# NFWY00124 Aurora Drive Noyes Slough 106 PA Update 11/10/2022

## Aurora Drive Noyes Slough Bridge No. 209 Replacement - Project Extent & Surrounding Parcels

**Expedited Re-evaluation APPROVAL FORM**  
(NEPA Assignment Program Projects)

**A. Project Name:** Aurora Dr Noyes Slough Bridge Replacement

Figure 1

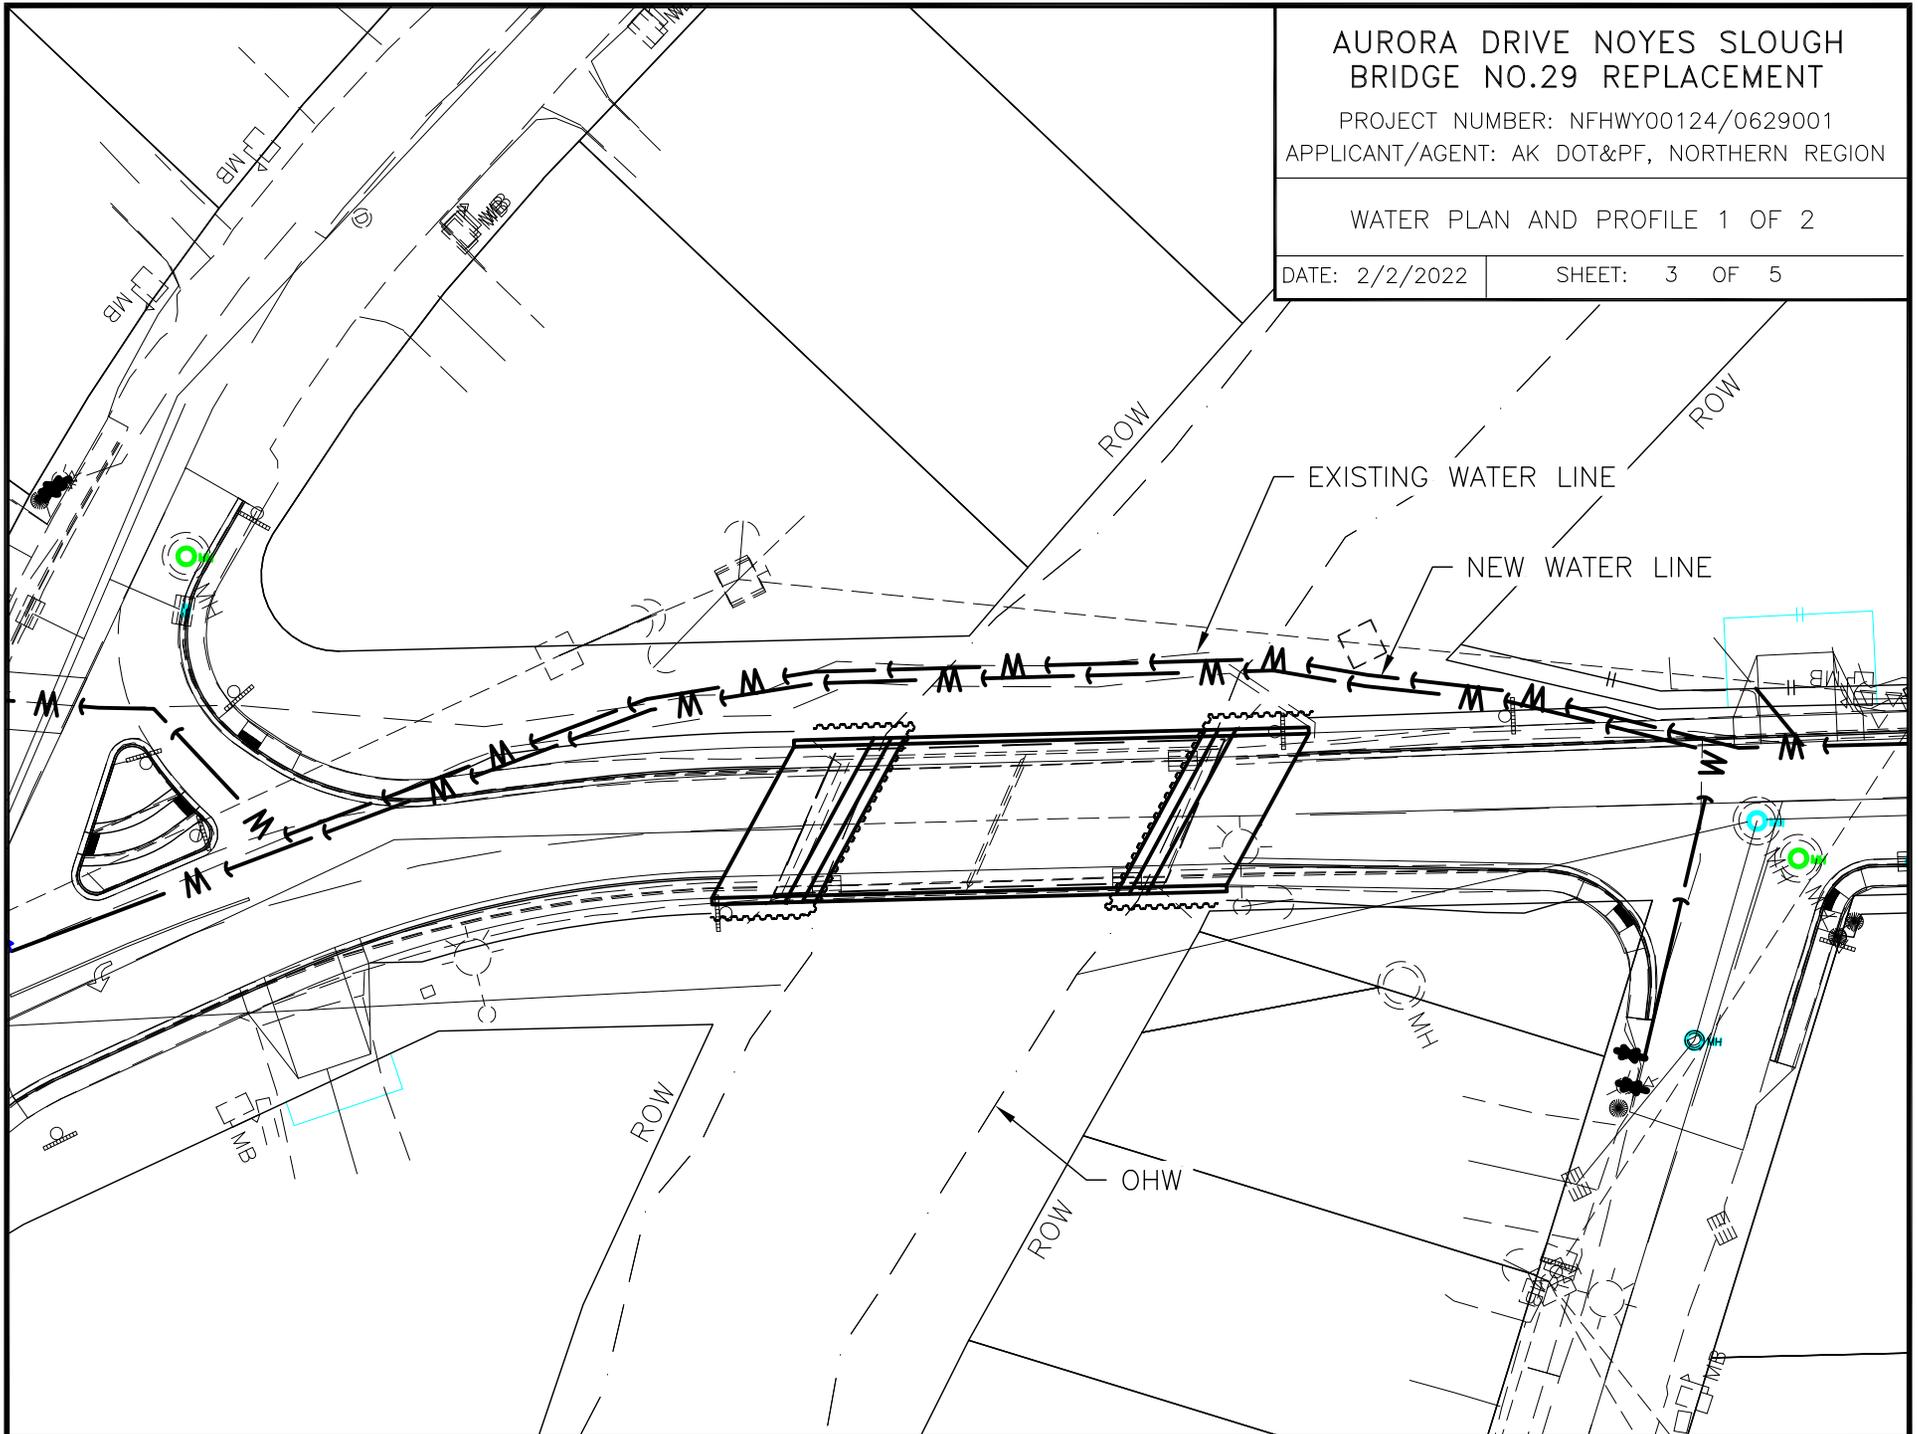
The 106 PA UPDATE expands the APE of the Aurora Drive Noyes Slough Bridge #0209 Replacement to include replacing and existing sidewalk with an ADA compliant sidewalk at the northern most intersection of Aurora Drive and Bridgewater Drive (red box on Figure 1). Additional work within the original APE will include relocation of a water main to a location shown as a dashed red line on Figure 1.

The update extends the project APE at the northernmost intersection of Aurora Drive and Bridgewater Drive (Figure 1).
